## Product Change Notice (PCN)

PCN Number: PCN-0451086R-01

Product(s) Affected: PJ-038-SMT and PJ-039-SMT

### PJ-038-SMT

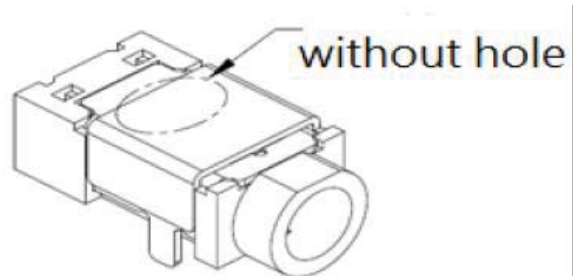
Reason(s) for Change: replacing existing mold maintain efficient production and quality.

Description of Change: appearance change as shown below:
